APPENDIX J

City of Madison Coordination

East Washington and Stoughton Road Ratings and Preferences

Subject: Staff Comments on North Stoughton Rd Design Alternatives, version 3. With Transportation Commission Comments

Concept 1

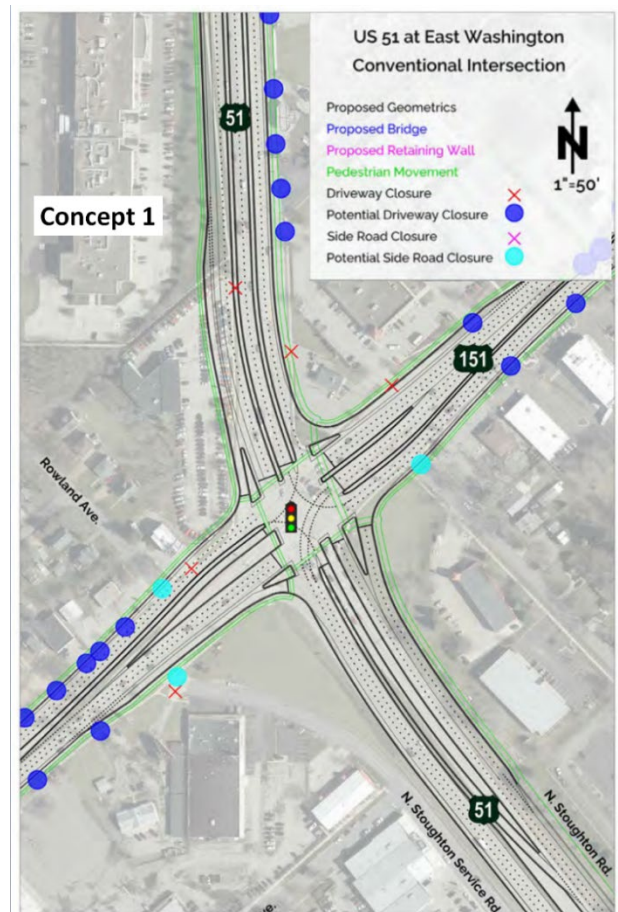
The existing Stoughton Rd and East Washington Ave intersection is poor with long crossing distances for pedestrians and bicycles. The proposed concept is similar to what exists with similar numbers of lanes. While poor, Concept 1's at-grade crossing is perhaps better and more urban than many of the concepts that have been presented.

This concept has relatively straight forward pedestrian and bicycle paths. Crossing distances are slightly longer due to increased island size. With the high volumes on both East Washington Ave and Stoughton Rd, it is important that pedestrians are able to cross each approach in a single phase, without having to use an island as a refuge. We encourage WisDOT to reconsider the need for the SBRT and EBRT slip lanes at East Washington & Stoughton Road. These slip lanes add complexity and delay to the pedestrian crossing.

We also encourage WisDOT to maintain some type of access between the North Stoughton Service Road and East Washington Ave.

The concept has up to three potential side road closures due to policy reasons. Because this access loss is policy rather than a geometric necessity, and these side road access have existed for decades as right-in/right-out driveways, staff recommend that these accesses be preserved.

This concept has numerous potential access removals, again for policy reasons rather than geometric. The loss of these access points would result in numerous relocations and require that land remain vacant for lack of access. As with street access, staff recommend that these accesses be preserved as right-in/right-out.

As mentioned, if potential access closures occur it would result in numerous relocations. Staff recommend these accesses be preserved. This would allow both preservation of uses and future redevelopment in most quadrants of the intersection.

Concept 2

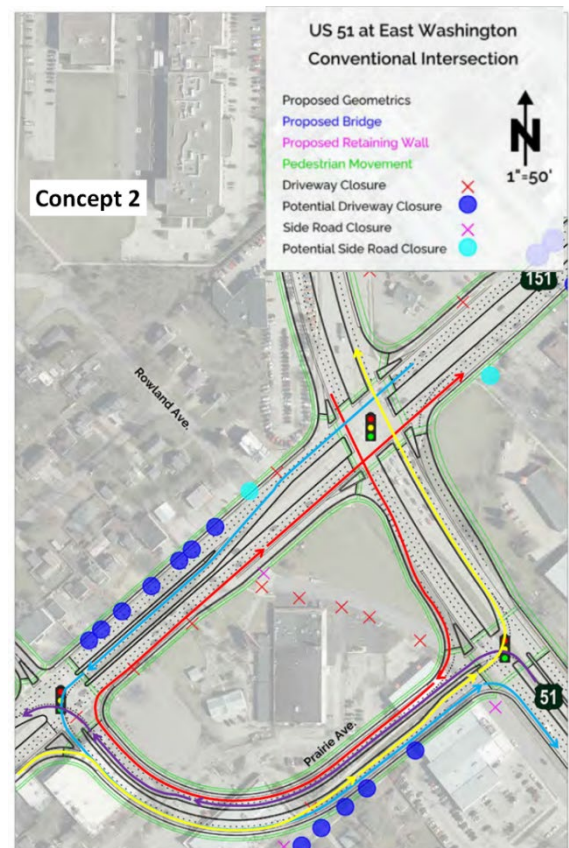
This concept, while adding one intersection to East Washington, reduces the size of the Stoughton Road/East Washington Ave intersection and keeps all movements at one level.

This concept has relatively straightforward pedestrian and bicycle paths. Crossing distances could be shorter due to reduced number of lanes that need to be crossed. We would encourage WisDOT to narrow the very large median islands that increase crossing distances and clearance times. While another intersection is added, the signal timing for both intersections would be more straightforward with fewer turning phases. As mentioned previously, with the high volumes on both East Washington Ave and Stoughton Rd, it is important that pedestrians are able to cross each approach in a single phase, without having to use an island as a refuge.

The concept has up to two potential side road closures due to policy reasons, and a realignment of the North Stoughton Rd Service Road. Because this access loss is policy rather than a geometric necessity, and these side road access have existed for decades as right-in/right-out driveways, staff recommend that these accesses be preserved. Staff also recommend access be allow on Prairie Ave, so that parcel would be available for redevelopment.

This concept has numerous potential access removals, again for policy reasons rather than geometric. As with the previous alternative, staff recommend that these accesses be preserved as right-in/right-out as they have currently existed for decades. It is important for access to be preserved on Prairie Ave so that land parcels on both sides are able to host active land uses.

As mentioned, if potential access closures occur it would result in numerous relocations. Staff recommend these accesses be preserved as right-in right-out. It is likely portions of the shopping mall in the southwest quadrant could be relocated. It is important that this parcel maintain active uses through the preservation of some type of access. Because this intersection type does not have grade differentials that mandate access closure, there may be more opportunity for active land uses adjacent to the corridor.

Concept 3

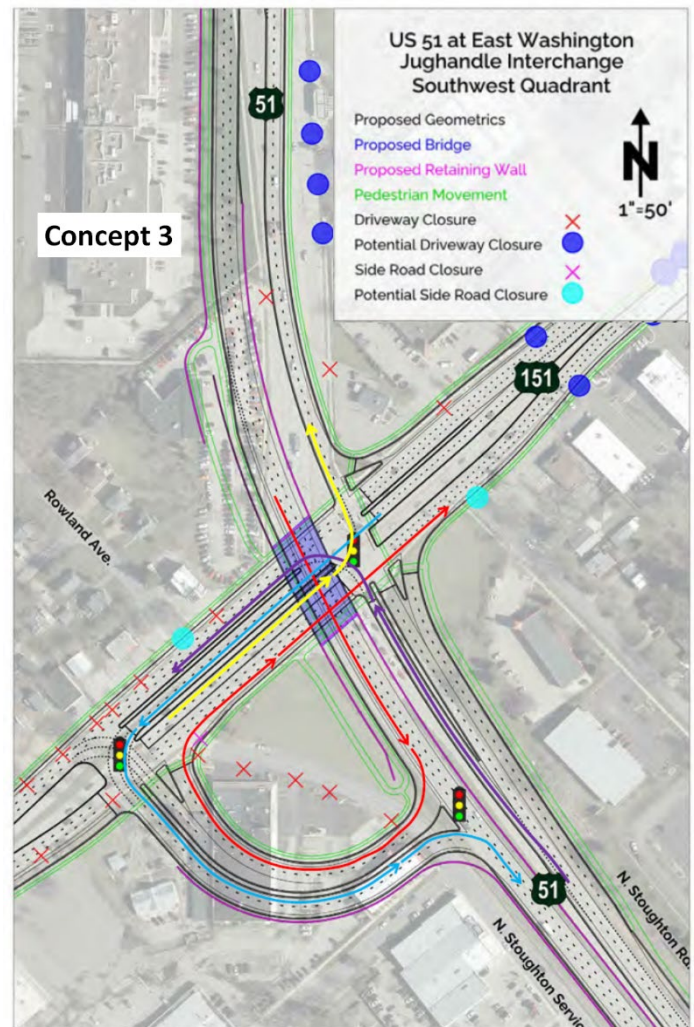
While grade separating one movement, this jughandle still incorporates signals in the northbound, southbound, eastbound and westbound directions. It adds intersection capacity without introducing a freeway interchange. This helps preserve urban speeds, and probably would not encourage speeding between up and downstream signalized intersections.

This concept reduces the number of lanes a pedestrian has to cross in the east-west direction by half, and eliminates many of the conflicting left turns from the signal timing. East-West pedestrian and bicycle routing is straightforward and direct. Extra efforts

are needed to provide pedestrian/bicycle connectivity in the north-south direction on the west side of the intersection. This includes, but is not limited to a signalized crossing on the west side of the jug handle intersection with East Washington. This was accomplished at Junction Rd/Mineral Point Rd through a spiraled path grade separation. The City of Madison recommends improving bike connectivity from neighborhoods south of East Washington to destinations and the Madison bike network north of East Washington.

The concept has up to two potential side road closures due to policy reasons. Again, staff recommends maintaining these sideroad access points as right-in/right-out.

This concept has numerous confirmed access removals. Some of these access removals are necessary due to grade changes, and the southwest quadrant ramp construction. Madison requests WisDOT re-evaluate the listed access removals in the westbound East Washington direction to see if all are necessary. These confirmed access removals would create a strip of relocations, and the ensuing vacant undevelopable land, that is not beneficial.

The access closures in the northeast quadrant would relocate Walgreens, an important area business. Since the grade separated lanes are in the southbound direction, there should be no additional grade challenges with providing access to Walgreens. Measures should be taken to preserve this access and business. Similarly, westbound East Washington Ave would have all accesses removed – resulting in a strip of relocations and corresponding vacant undevelopable land. Yet, there appears to be no great profile differential on East Washington Ave that would mandate these access closures. Staff recommend these accesses be preserved as right-in right-out to the extent possible. The southwest quadrant would be relocated, and there are no alternatives to this relocation. Yet, with the preservation of access, the northeast and southeast quadrants could remain active land uses. The southbound horizontal curve is designed so that it could relocate 3571 Stoughton Road. This building should be preserved.

Concept 4

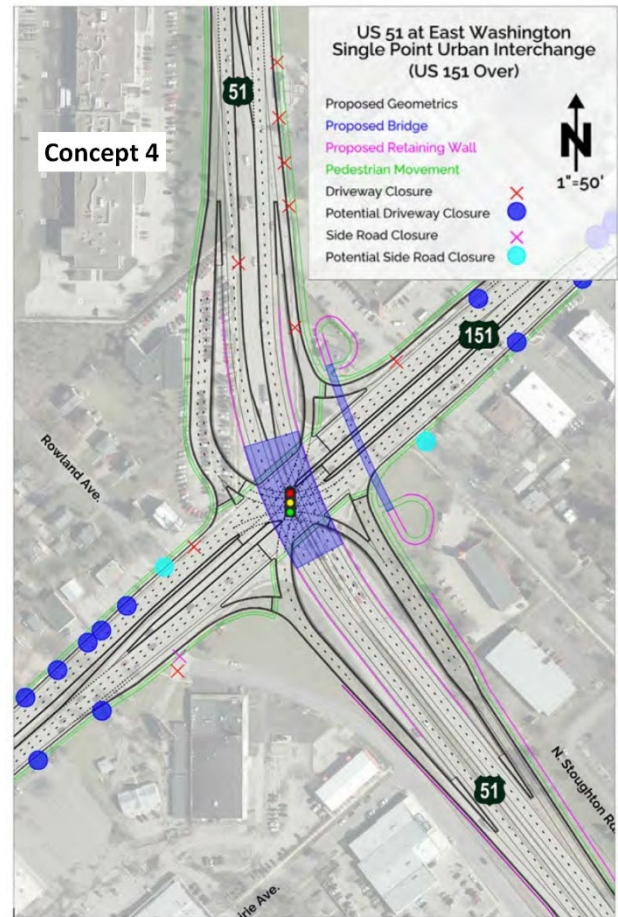
This concept is one of the more impactful concepts. It constructs a freeway interchange between two signalized intersections, which will likely create speeding problems in the urban street section to the north. Examples of where isolated interchanges pose similar challenges exist at Aberg and the at-grade intersections north of this interchange.

This concept technically reduces the number of lanes a pedestrian has to cross in the east-west direction, but there are multiple islands a pedestrian would have to travel through. Single Point Interchanges are very poor for crossings in the grade separated direction because there are no traffic gaps in the turning or through movements. Consequently, this movement must be handled through a grade separated pedestrian crossing. At the Verona Road Interchange, this is handled with a tunnel on the south approach. At the US 51/East Washington interchange, pedestrian crossing would be accommodated on the east approach through a spiraled ramp. No accommodations would be provided on the west approach. There is concern that some pedestrians would cross at-grade in the north-south direction to avoid the indirection of the pedestrian bridge on the east approach, and the total lack of north-south pedestrian accommodations on the west approach. Madison has had poor compliance/usage of the pedestrian bridge similar to this proposal crossing East Washington Ave at Marquette

Pedestrian crossings in the East – West direction would be broken into 4 separate crossings which would add substantial signal delay to the pedestrian crossing. Vulnerable users, such as the visually challenged or young bike riders, would have difficulty traveling through the interchange. The pedestrian crossings of some slip lanes shown may pose a hazard as people crossing on foot often disobey pedestrian signals when the crossing distance is short and delay high.

The concept has up to two potential side road closures due to policy reasons. Again, staff recommends maintaining these sideroad access points as right-in/right-out.

This concept has numerous confirmed access removals. Some of these access removals are necessary due to grade changes associated with the ramps. It is likely most entities in the northeast quadrant (Walgreens) would need relocation. Additionally, most businesses on the east side of Stoughton Rd and north of East Washington would lose access and be relocations.

For East Washington, Madison requests WisDOT evaluate the potential access removals in the westbound East Washington direction to see if all are necessary. If realized, these access removals would create a strip of relocations, and the ensuing vacant undevelopable land, that is not beneficial.

Unavoidable access closures in the northeast quadrant would relocate Walgreens, an important area business, and businesses north of Walgreens. Similarly, westbound East Washington Ave would likely have accesses removed because of their proximity to a freeway ramp terminal. This would result in a strip of relocations and corresponding vacant undevelopable land. Staff recommend these accesses be preserved as right-in right-out to the extent possible.

Note: If WisDOT feels that some type of interchange alternative must be brought forward, an alternative to the Single Point Urban Interchange could be a tight diamond interchange with north-south being the dominant direction. Staff had previously provided negative comments to WisDOT regarding a tight diamond, but a tight diamond decreases complexity with pedestrian and bicycle routing.

Concept 5

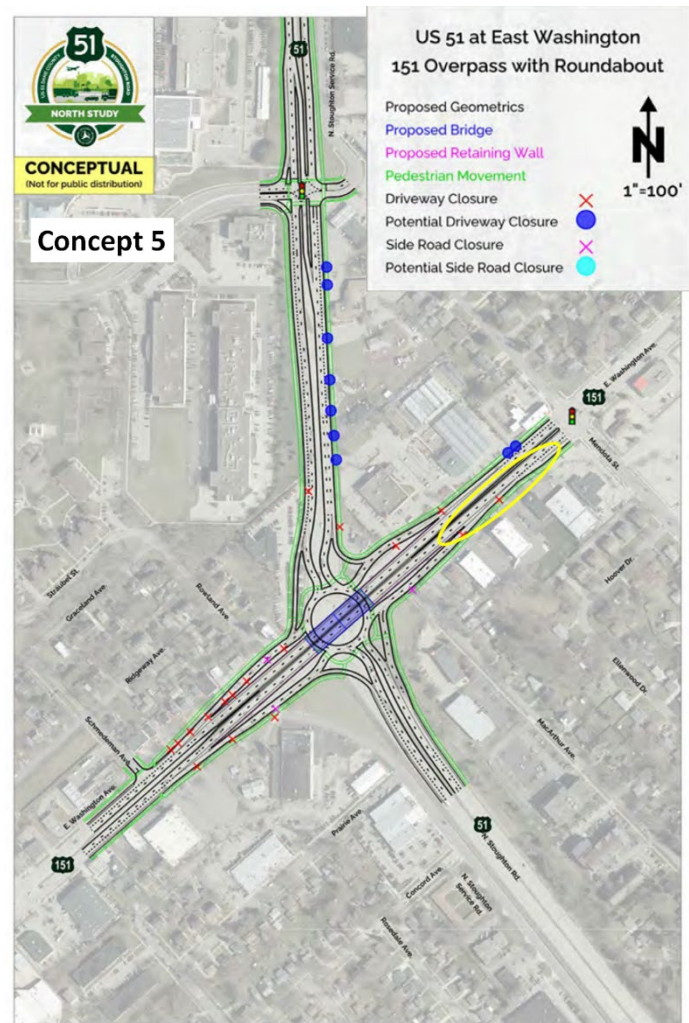
This concept is also one of the more impactful concepts. It constructs a somewhat unconventional interchange with the east-west direction being the dominant direction. The interchange is placed between two signalized intersections on East Washington Ave. This introduces a freeway treatment between two urban intersections. This could encourage speeding between signals on East Washington.

Concept 5 has pedestrians and cyclists cross the intersection at the depressed roundabout level. Pedestrian crossings at roundabouts tend to be indirect, and the roundabout bypass lanes in the intersection accentuate this challenge. North-south crossings would have fewer vehicles and more traffic gaps to cross. East-west pedestrians would have to cross larger traffic volumes without the aid of a traffic signal. Bicycle traffic would have very indirect routing through the interchange unless they chose to take a lane. Because of the bypass lanes, a cyclist would likely need to stop and wait 4 times to travel east-west through the roundabout.

Madison requests WisDOT reconsider the need for slip lanes for the EBRT, SBRT, and WBRT directions. Some may be needed for truck turning radii, but the extent that they can be reduced or eliminated would reduce speeds.

The concept has three confirmed and unavoidable access street closures

This concept has numerous confirmed access removals. Some of these access removals are necessary due to grade changes associated with the ramps. It is likely most entities in the northeast quadrant (Walgreens) would need relocation. Additionally, most properties west of Stoughton Rd and north of East Washington would lose access and be relocations.

For East Washington, Madison requests WisDOT evaluate the potential access removals in the westbound East Washington direction to see if all are necessary. If realized, these access removals would create a strip of relocations, and the ensuing vacant undevelopable land, that is not beneficial.

Unavoidable access closures in the northeast quadrant would relocate Walgreens, an important area business, and businesses north of Walgreens. Similarly, westbound East Washington Ave would likely have accesses removed because of their proximity to a freeway ramp terminal. This would result in a strip of relocations and corresponding vacant undevelopable land. Staff recommend these accesses be preserved as right-in right-out to the extent possible.

Concept 7

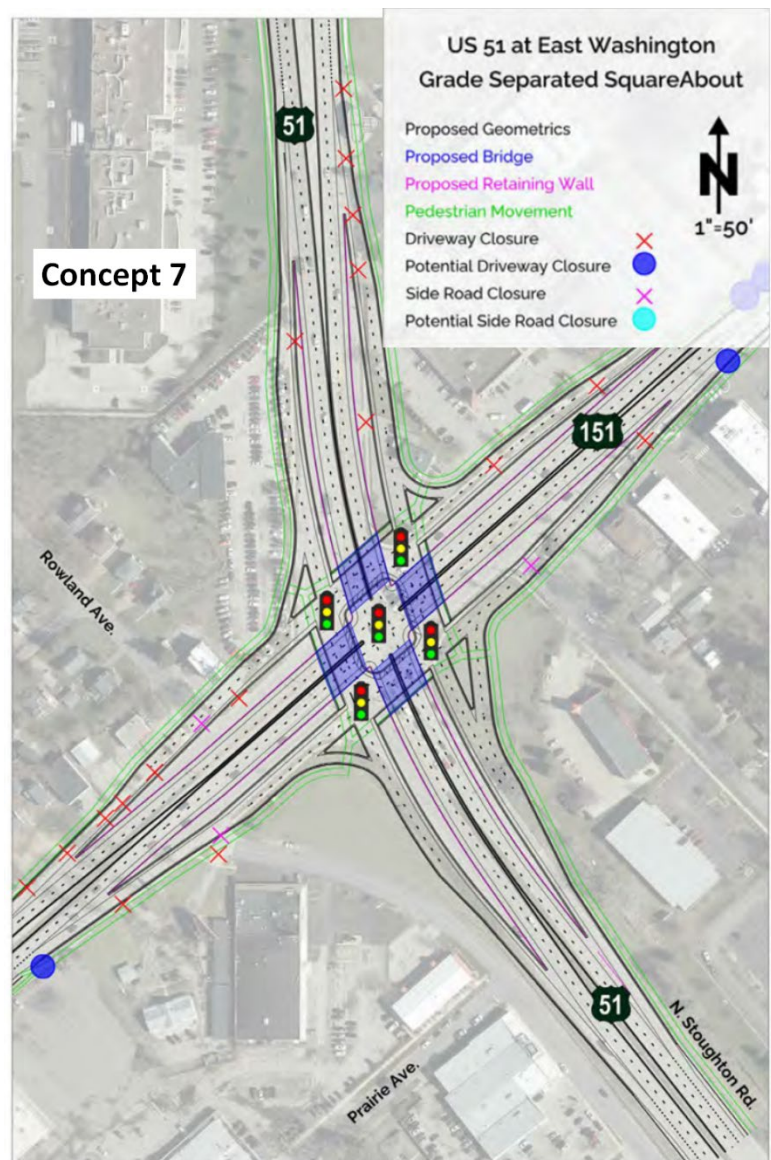
The benefits and impacts of this concept are very similar to Concept 6, except the signalized intersections for turning movements would provide simpler and more direct routes for pedestrians and bicycles. As mentioned with Concept 6, the signalized intersection for through movements could be unexpected for what appears to be an interchange and lead to more crashes.

This concept is also one of the more impactful concepts. It constructs a grade separated intersection between two signalized intersections on East Washington Ave. As mentioned, the signal for through movements would be unexpected, yet would be consistent with up and down stream signals on both East Washington and Stoughton Road.

Concept 7 has pedestrians and cyclists cross the intersection at the raised mini couplet level. The crossings are direct and straight forward, and the short-cycle signal timing would not create a lot of delay. Generally pedestrian crossing with this concept are better than those for Concept 6.

Because all through movements are removed and depressed, crossing travel volumes for pedestrians and cyclists are much more manageable.

The concept has three confirmed and unavoidable access street closures. Some type of connection (not shown) would be needed for the Stoughton Rd frontage road.

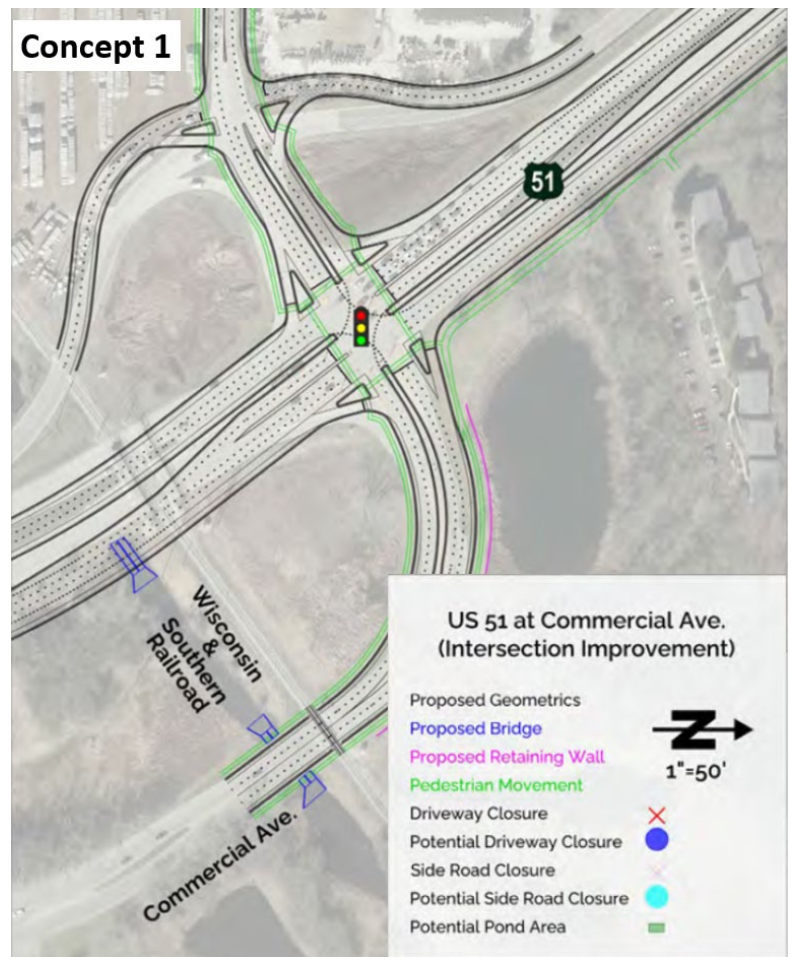
The realignment of the North Stoughton Service road provides very modest throat distance improvements for the impacts generated. Staff recommend revising this portion of the alternative.

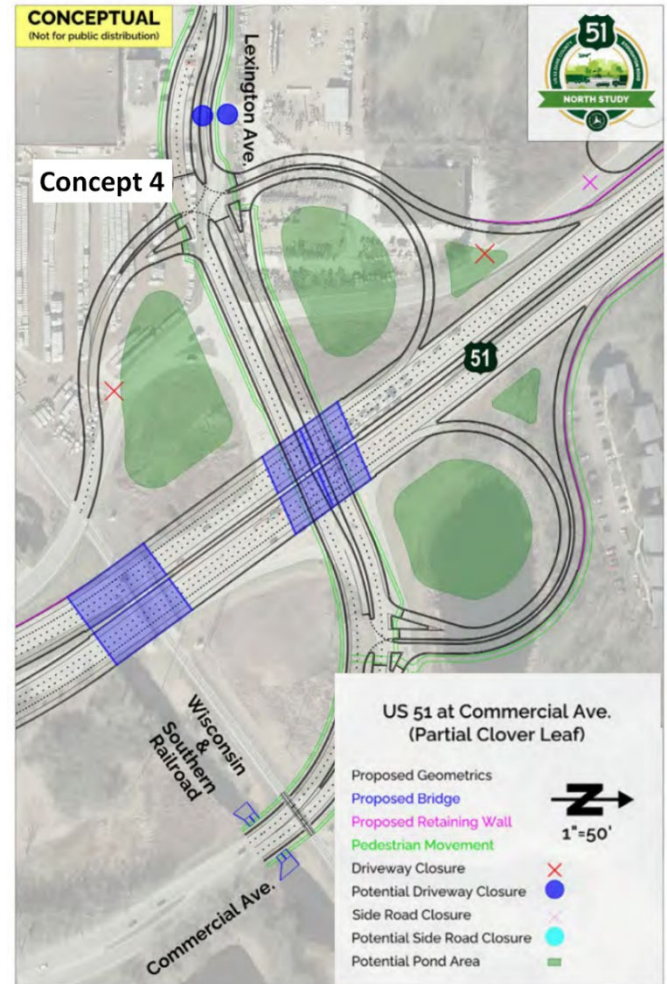
Concept 4 places a freeflowing interchange ramps just 0.3 miles from the signalized Highway 30 ramp terminals, and 0.4 miles the signalized East Washington Ave intersection. The freeflowing ramps are contrary to the intersection control both up and down stream and could lead to higher speeds and more severe crashes. Concept 4 also requires two bridges and has greater right of way impacts. Therefore Concept 4 is not recommended.

Figure 2 Stoughton Road/East Washington Alternatives

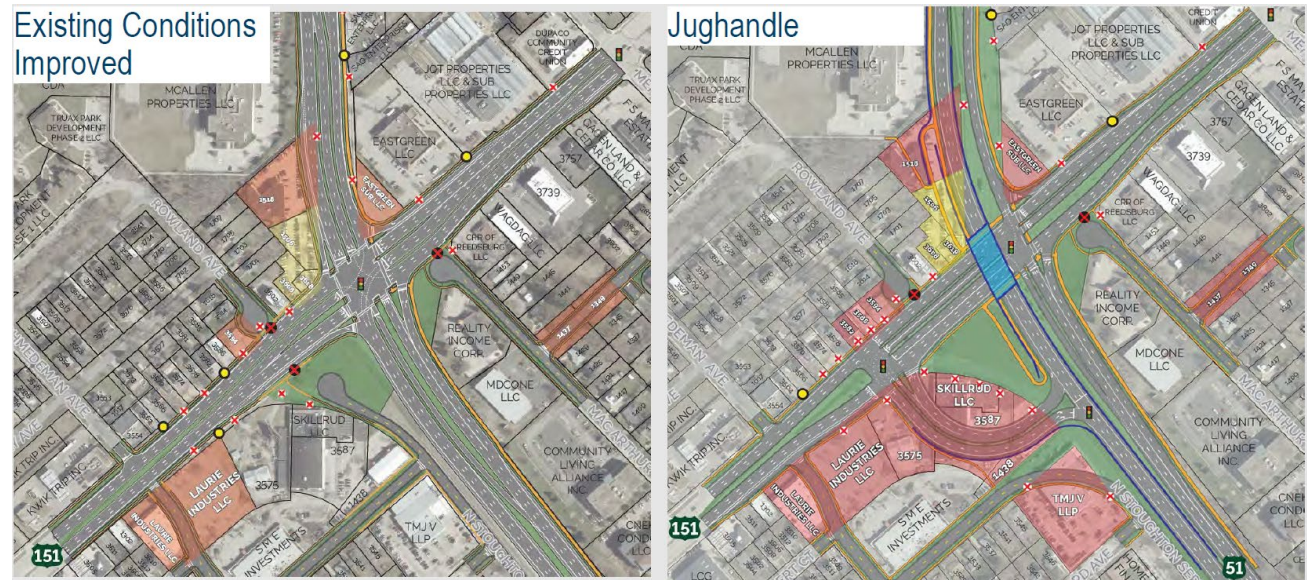
For the remaining alternatives, Madison prefers the at-grade intersection alternative over the jug-handle intersection alternative. While providing better ped/bike crossing, the jug-handle only removes 15 to 20 percent of the traffic from the intersection yet requires over 20 driveway closures and 11 relocations. The impacts are large and permanently preclude investment/development of almost 10 acres of land.

Madison requests that the driveway closures be reduced to the extent possible. These driveways have operated as right-in/right-out for decades with little effect on injury crashes. We believe maintaining these driveways does not pose a significant safety risk and will prevent at least 5 relocations.
